**PEACH CREEK ENVIRONMENTAL PARK
SAN JACINTO COUNTY, TEXAS
TCEQ PERMIT APPLICATION NO. MSW 2406**

Technically Complete Application

Addendum 2 to Volume 2, Part III of the Technically Complete Application

**TYPE I PERMIT APPLICATION
PART III – SITE DEVELOPMENT PLAN**

CITIZEN'S CONVENIENCE CENTER PLAN

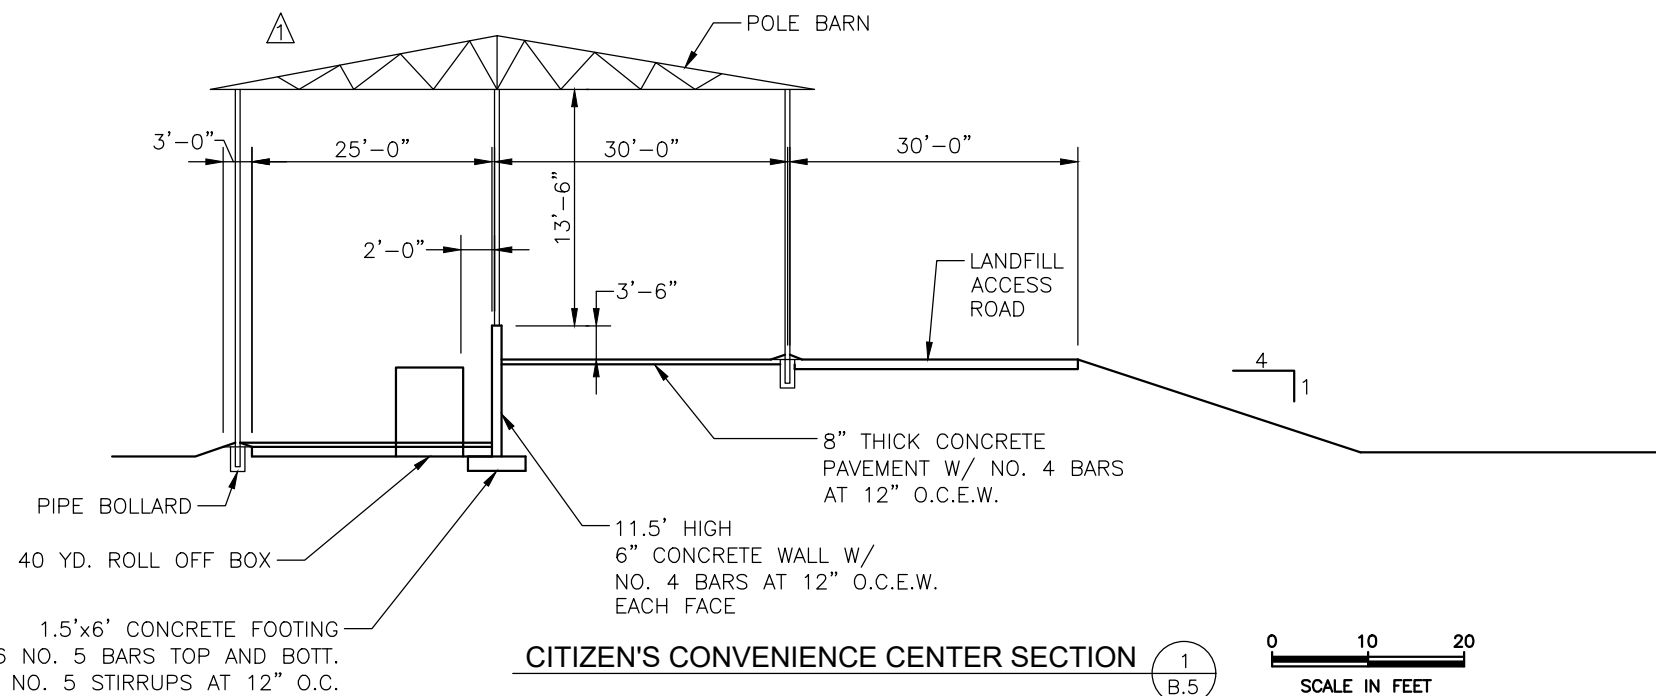
- citizen's convenience center configuration revised.

GATE HOUSE AND SCALES PLAN
PEACH CREEK ENVIRONMENTAL PARK
TYPE I PERMIT APPLICATION
SAN JACINTO COUNTY, TEXAS

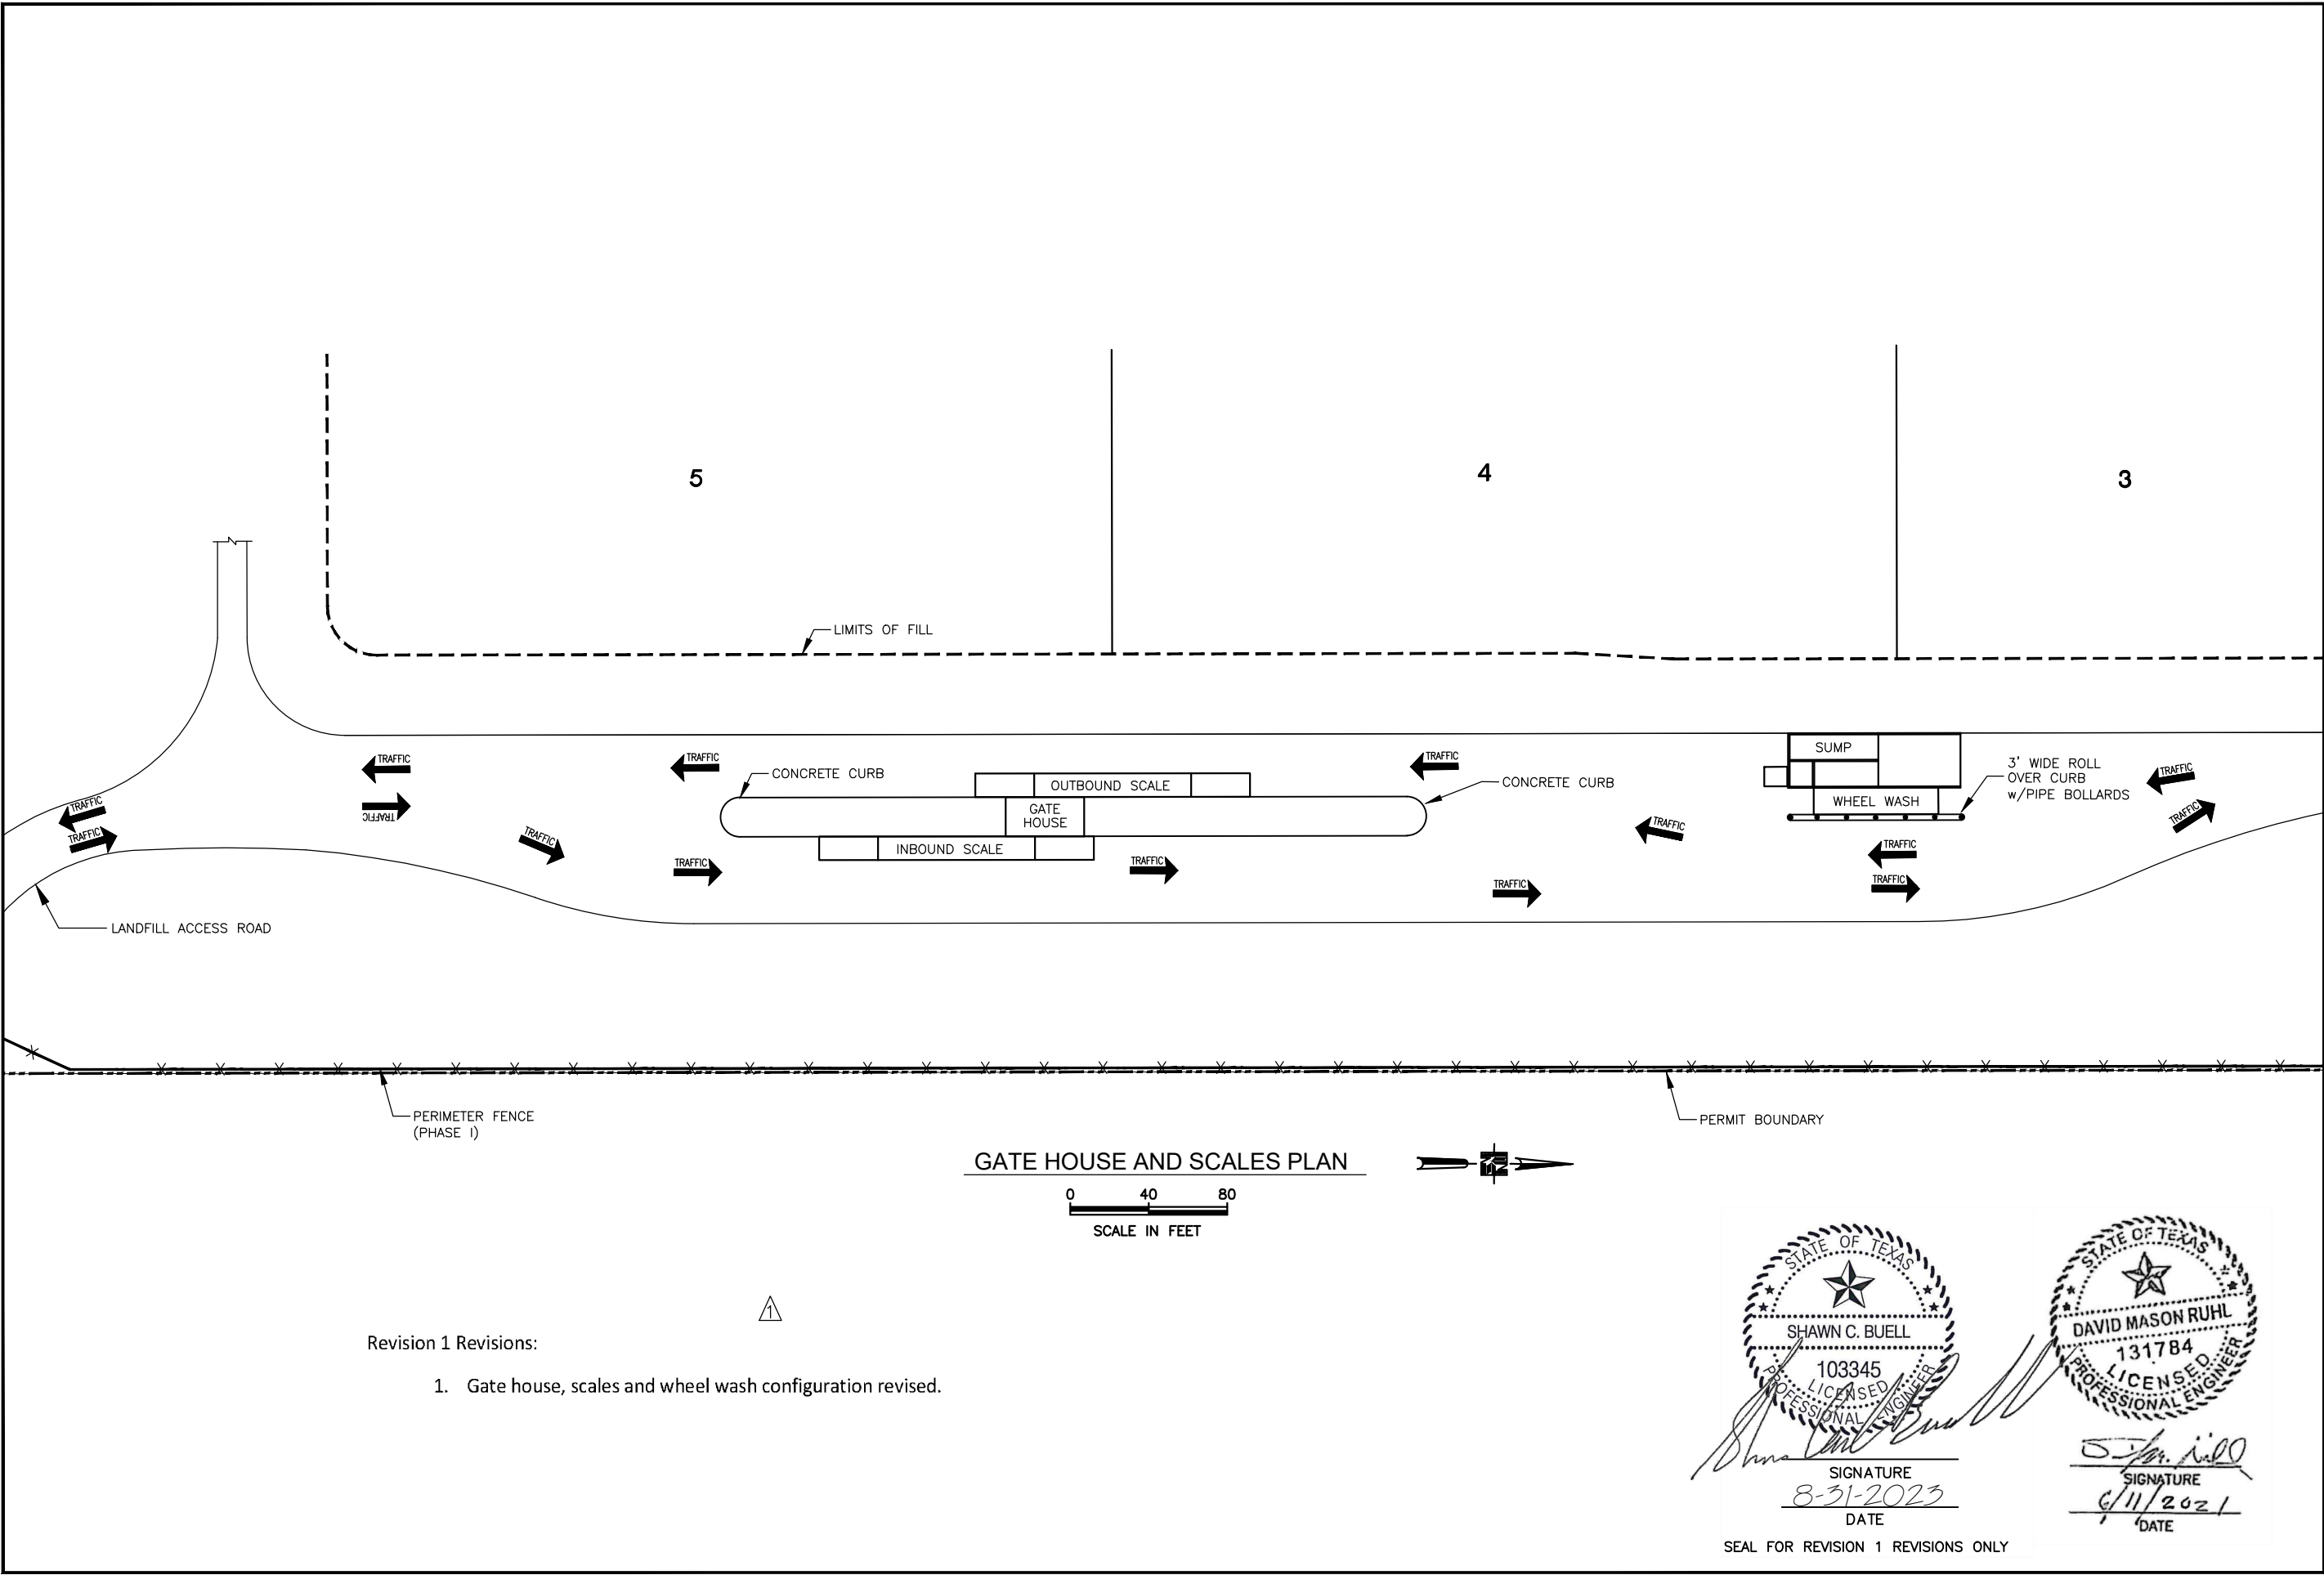
- Revision 1 Revisions:
- Gate house, scales and wheel wash configuration revised.

C11

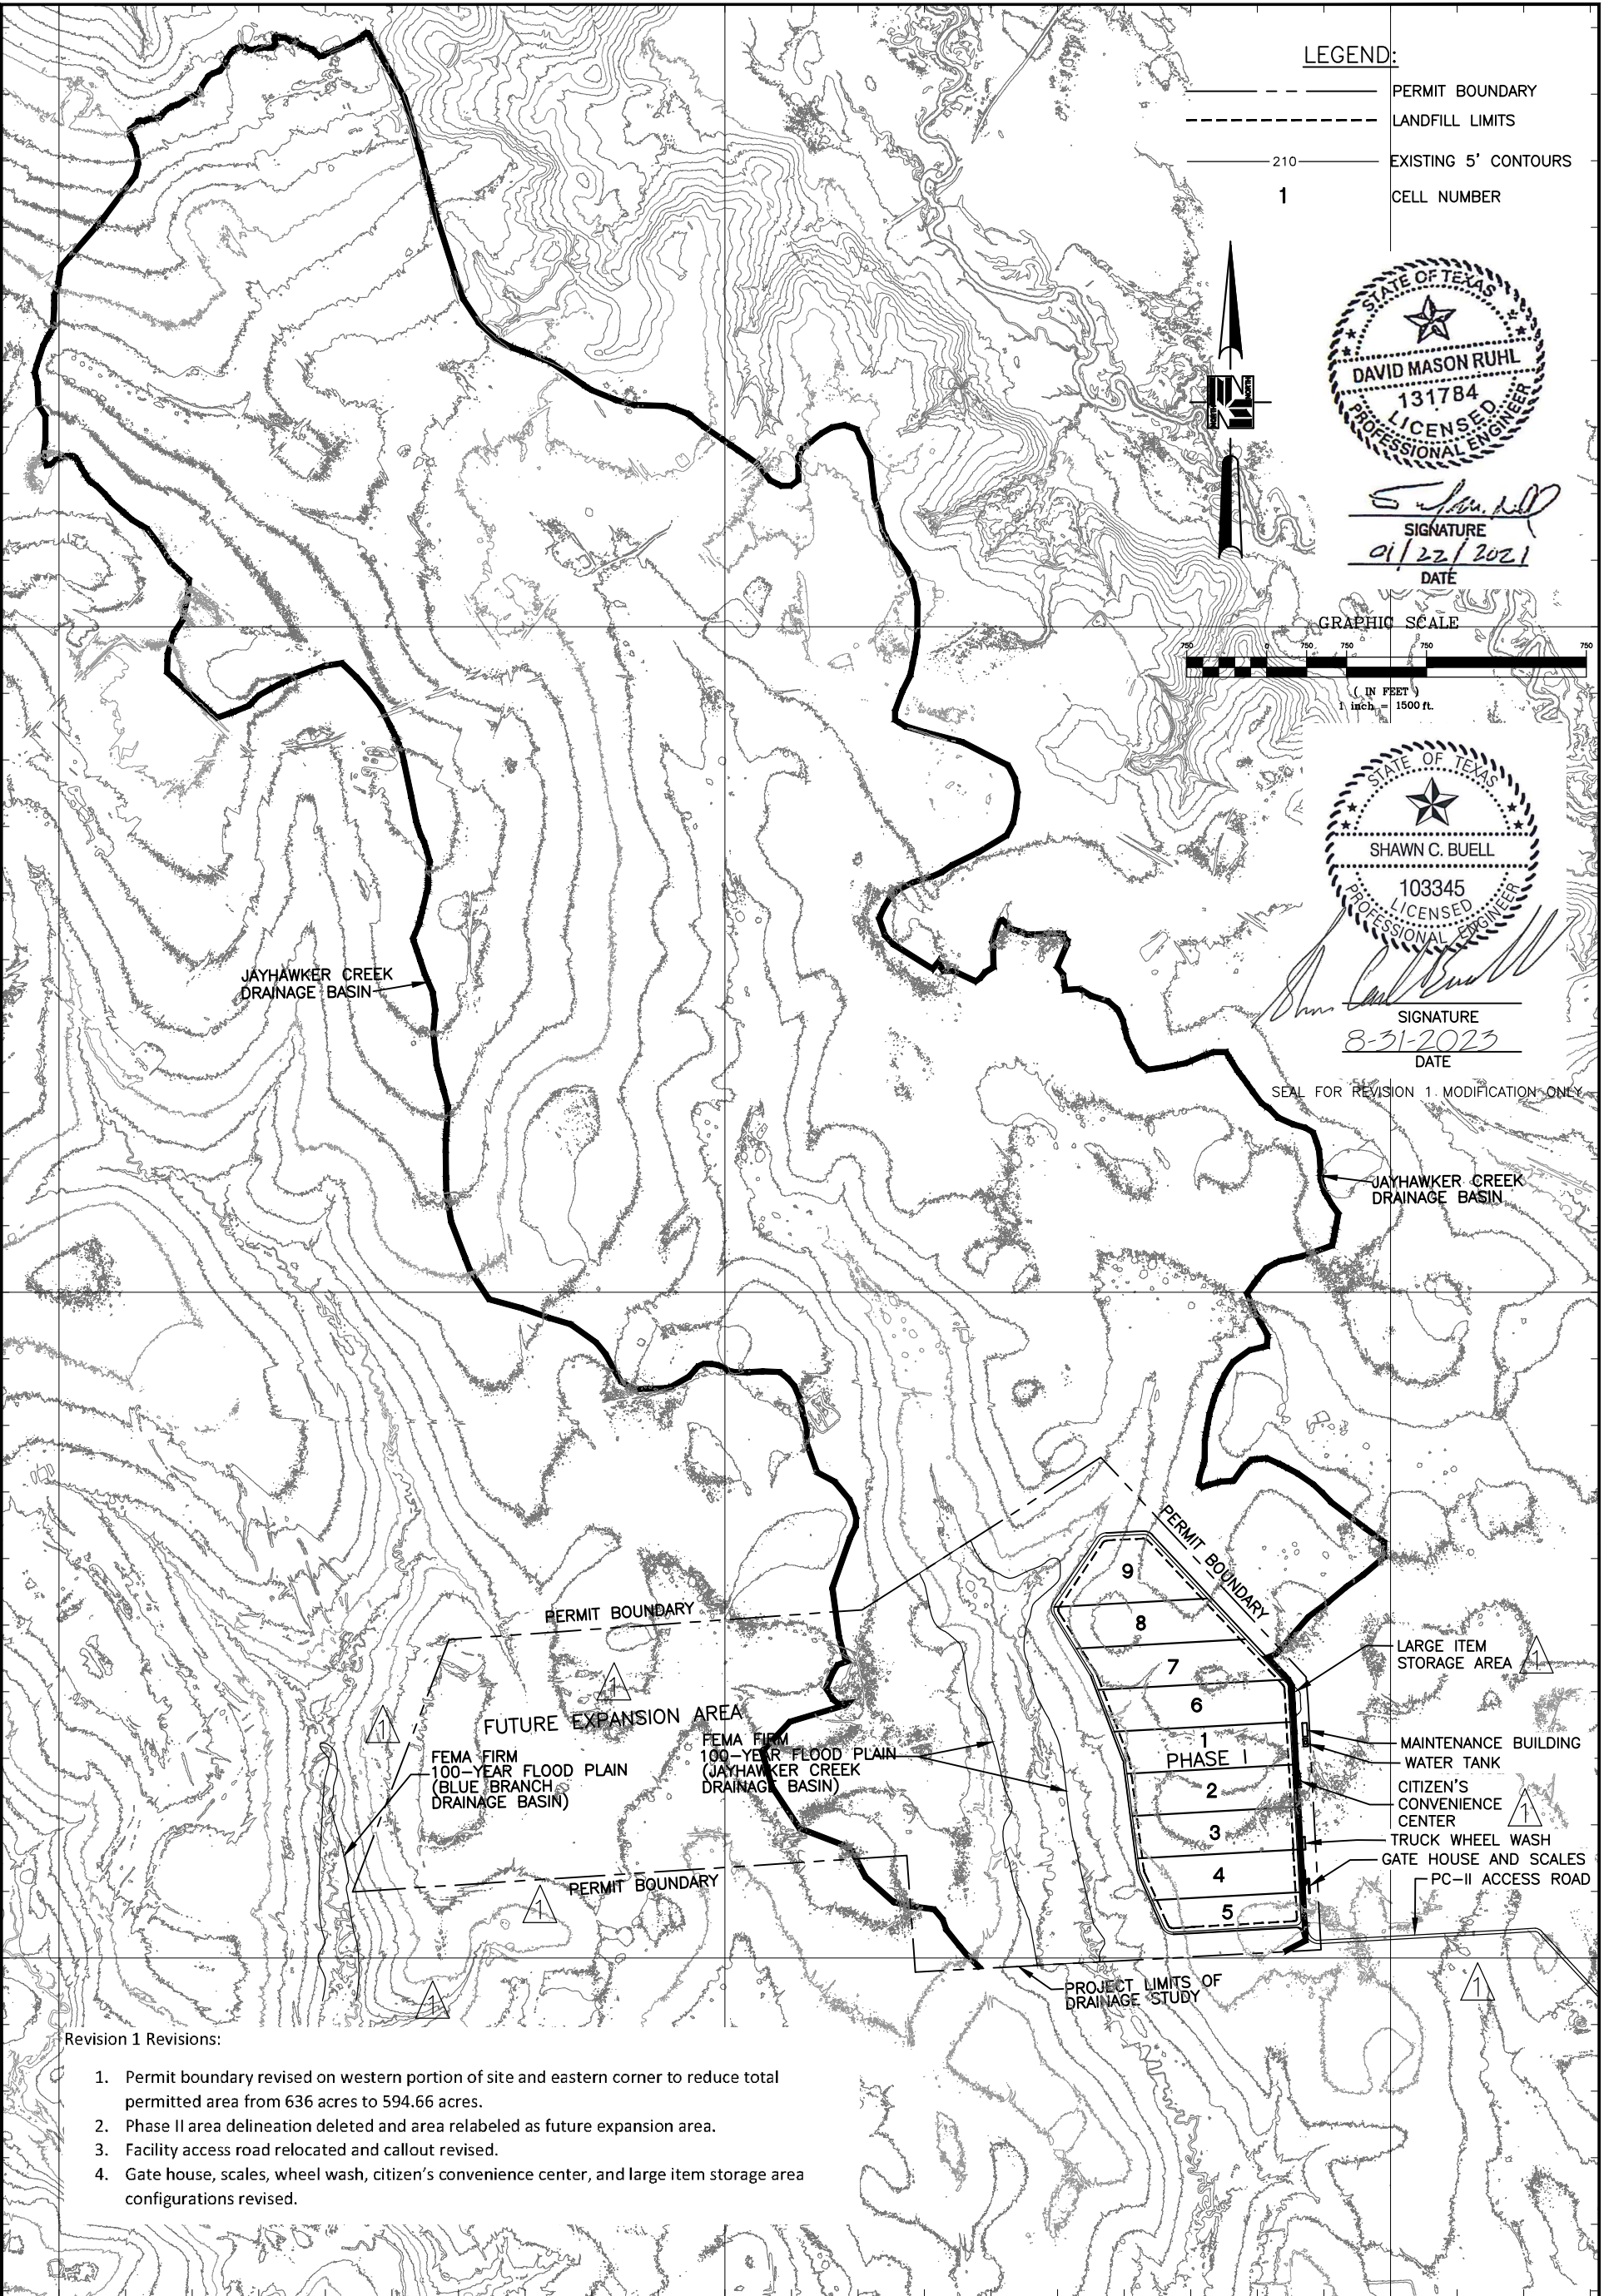
- Revision 1 Revisions:
1. Permit boundary revised on western portion of site and eastern corner to reduce total permitted area from 636 acres to 594.66 acres.
 2. Phase II area delineation deleted and area relabeled as future expansion area.
 3. Facility access road relocated and callout revised.
 4. Gate house, scales, wheel wash, citizen's convenience center, and large item storage area configurations revised.
